A. DESCRIPTION OF THE TECHNICAL SPECIFICATIONS AMENDMENT REQUEST

The proposed changes to Technical Specification sections 1.0, 2.0, 3/4.1.1, 3/4.1.2 and 3/4.10.1 reduce the boration requirements when shut down, by modification of the shutdown margin requirements as follows:

G. MARKED-UP TECHNICAL SPECIFICATION CHANGE PAGES:

FIGURE 3.1 - 1A

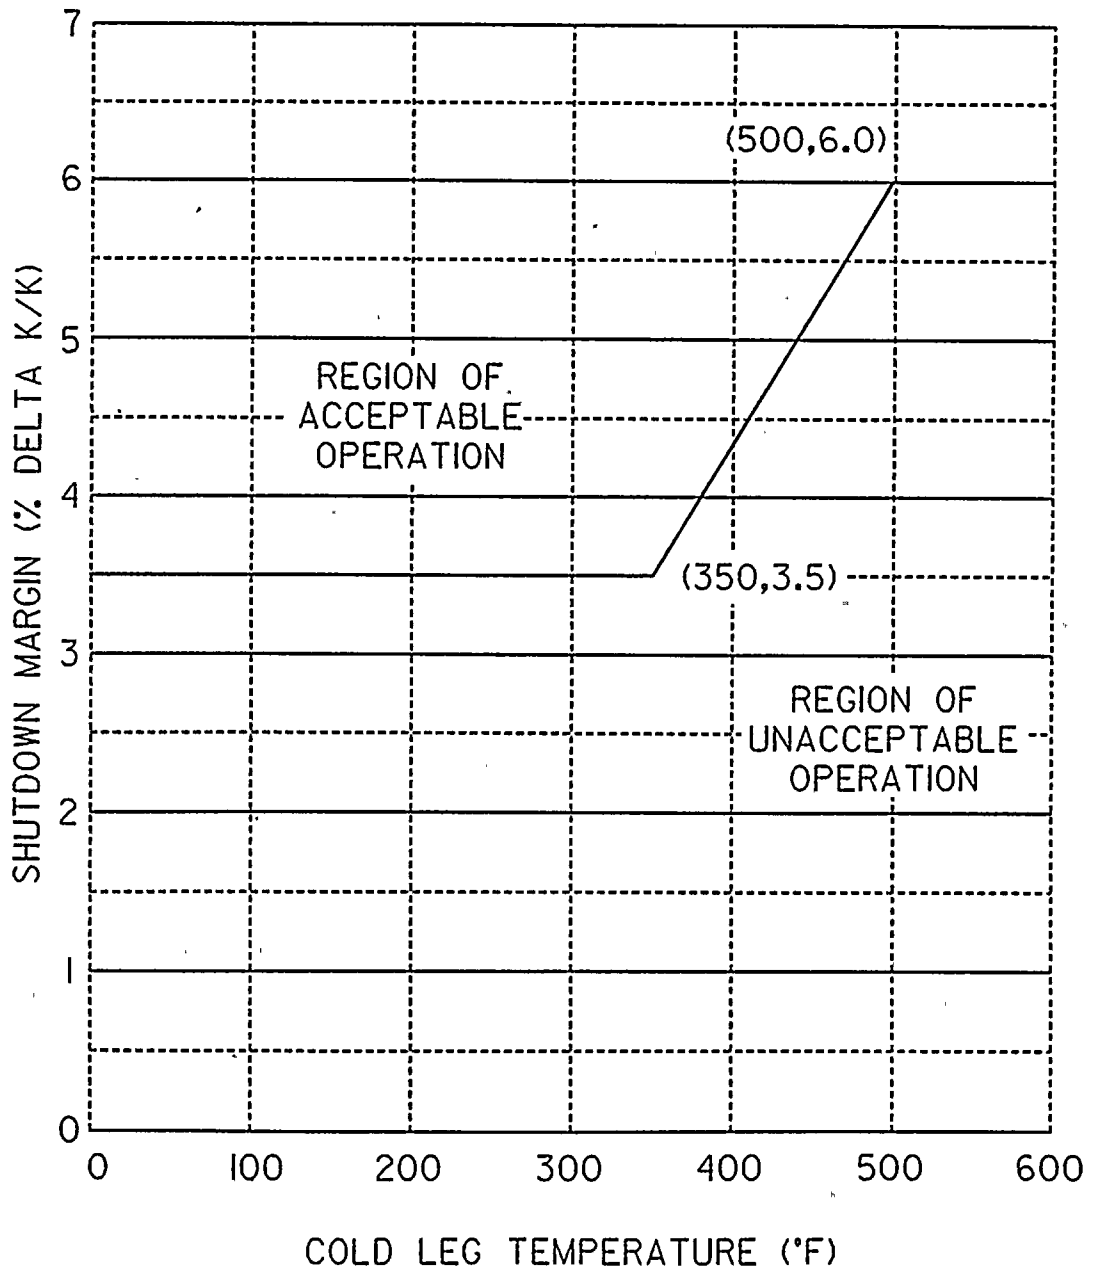
Delete
* ~~Whenever the reactor coolant level is below the bottom of the pressurizer in MODE 5, one and only one charging pump shall be OPERABLE, by verifying at least once per every 7 days that power is removed from the remaining charging pumps.~~

FIGURE 3.1 - 1A

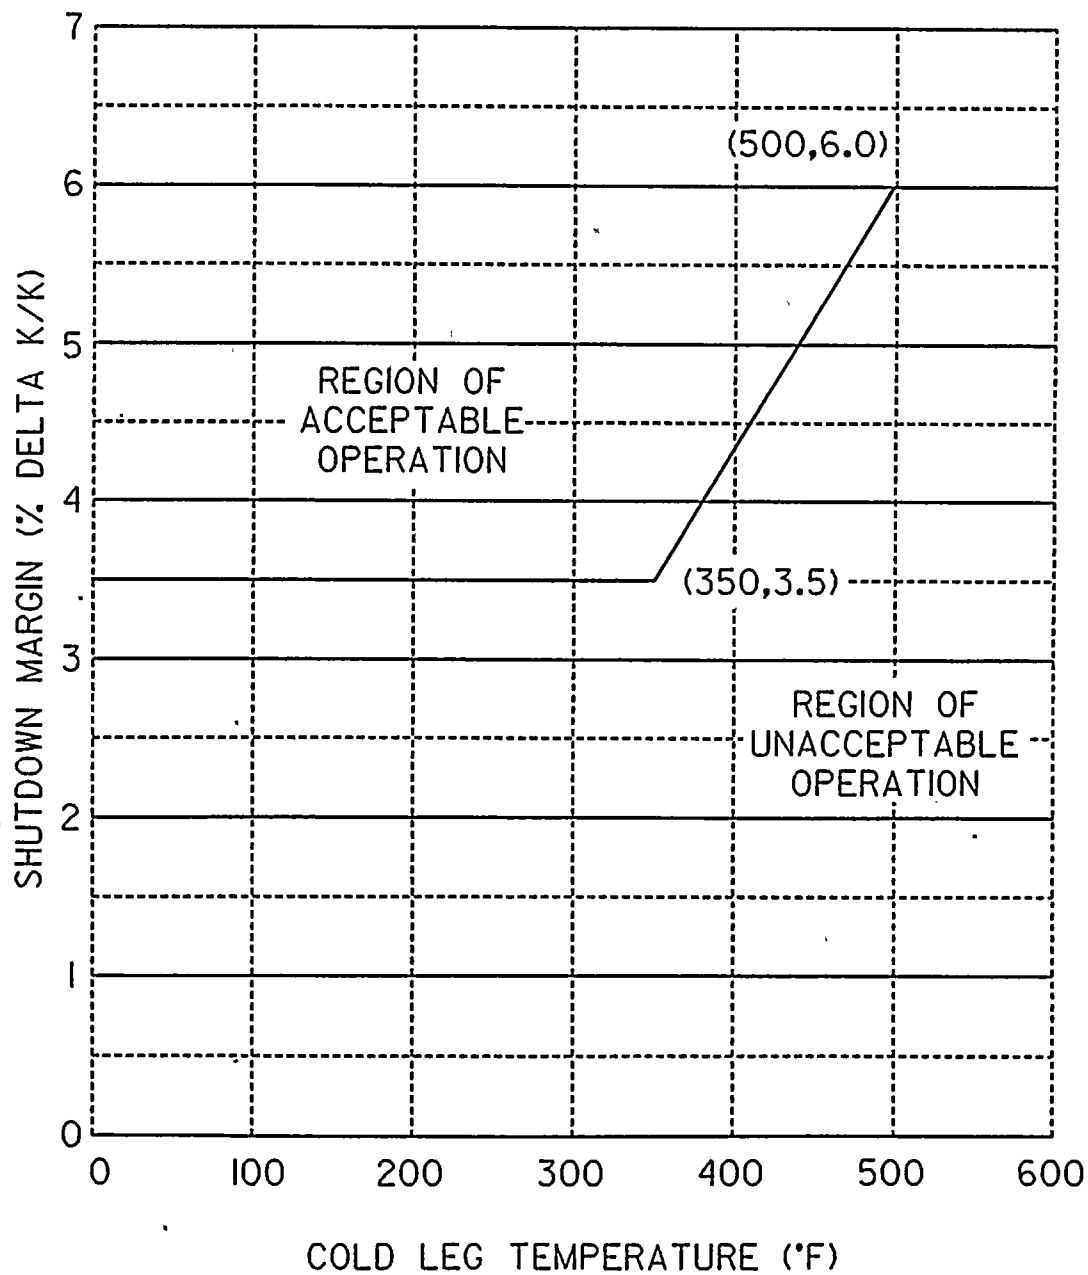
* ~~Whenever the reactor coolant level is below the bottom of the pressurizer in MODE 5, one and only one charging pump shall be OPERABLE, by verifying at least once per every 7 days that power is removed from the remaining charging pumps.~~

FIGURE 3.1 - 1A

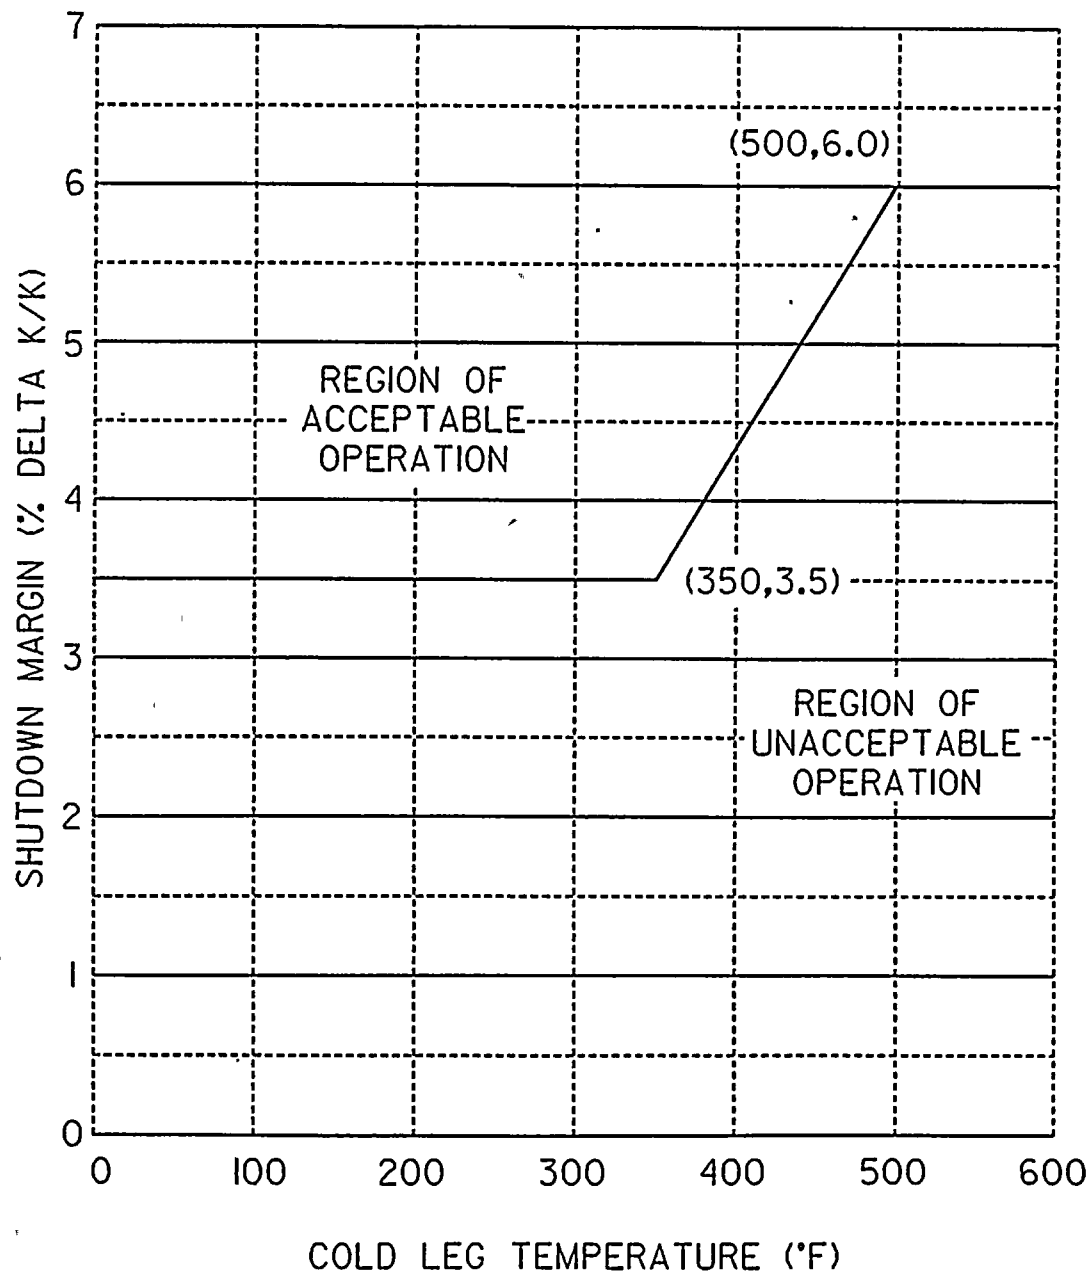
2. Limiting Conditions for Operation (LCOs) 3.1.1.1 and 3.1.1.2 require that for Modes 1-4, the shutdown margin be greater than or equal to 6% delta K/K, and for Mode 5, greater than or equal to 4% delta K/K. The proposed changes revise the shutdown margin requirements for Modes 1-5 according to full length Control Element Assembly (CEA) position. The revised Tech Spec 3.1.1.1 is applicable when all full length CEAs are fully inserted and requires that for Modes 3-5, the shutdown margin be greater than or equal to 2% delta K/K. The revised Tech Spec 3.1.1.2 is applicable when any full length CEA is withdrawn and requires that for Modes 1-5, the shutdown margin be greater than or equal to that given in a new Figure 3.1-1A. For reactor coolant cold leg temperature less than or equal to 500°F, K_{N-1} shall be less than 0.99. The LCO action statements are also revised to require boration when the above shutdown margin requirements are not met.

3.1.1.1 The SHUTDOWN MARGIN shall be greater than or equal to ^{1.0%} ~~6.0%~~ delta k/k.

With the SHUTDOWN MARGIN less than ^{1.0%} ~~6.0%~~ delta k/k, immediately initiate and continue boration at greater than or equal to 26 gpm to reactor coolant system of a solution containing greater than or equal to 4000 ppm boron or equivalent until the required SHUTDOWN MARGIN is restored.

4.1.1.1.1 The SHUTDOWN MARGIN shall be determined to be greater than or equal to ^{1.0%} ~~6.0%~~ delta k/k:

FIGURE 3.1 - 1A

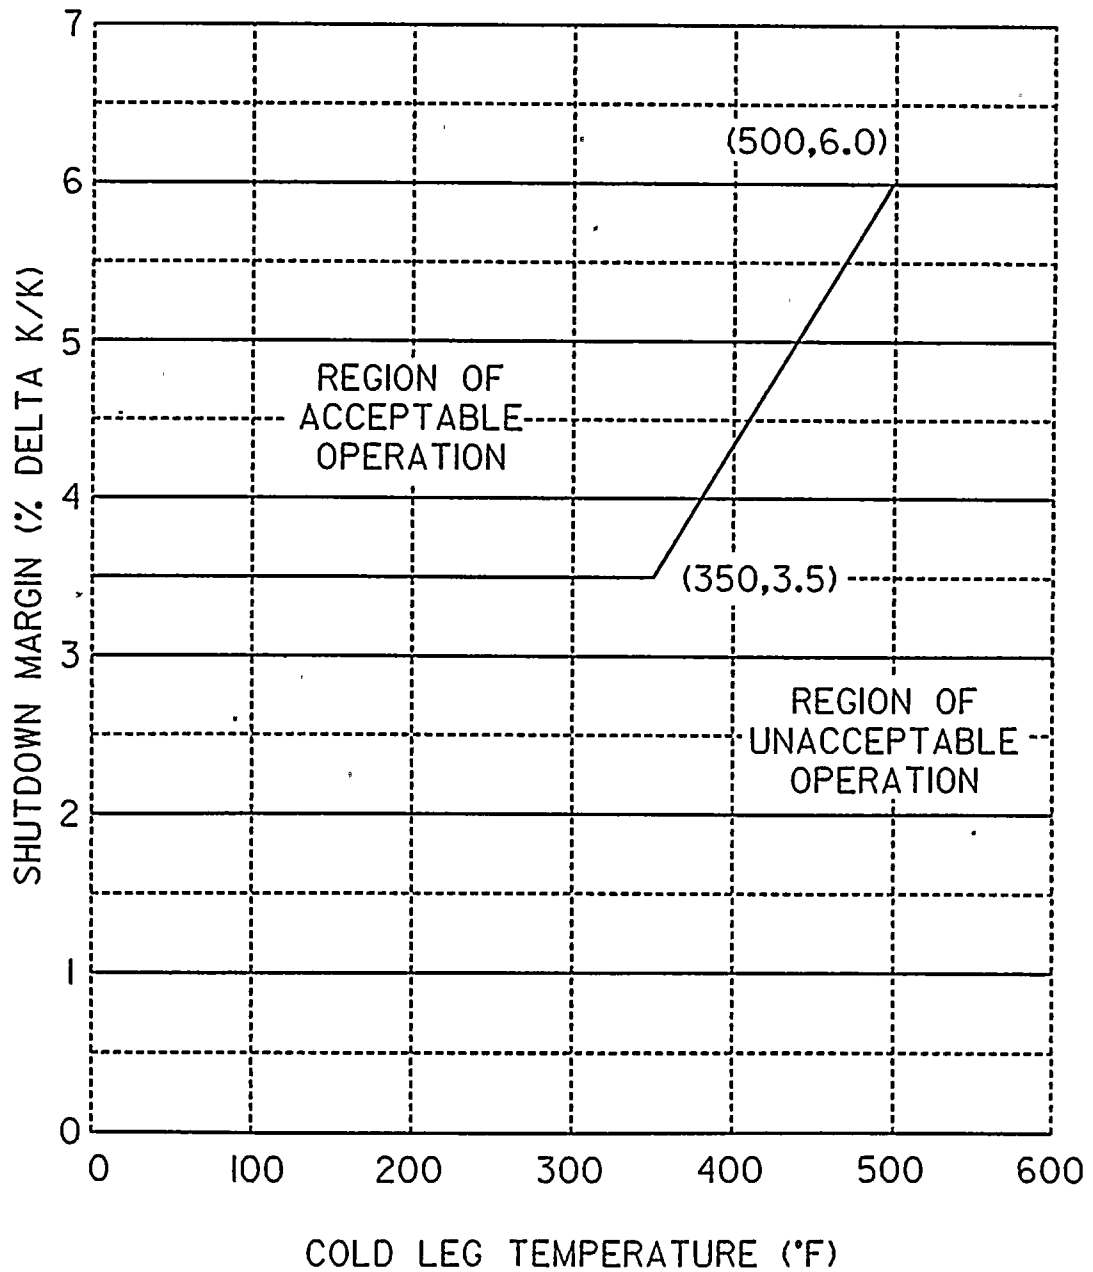
* ~~Whenever the reactor coolant level is below the bottom of the pressurizer in MODE 5, one and only one charging pump shall be OPERABLE, by verifying at least once-per every 7 days that power is removed from the remaining charging pumps.~~
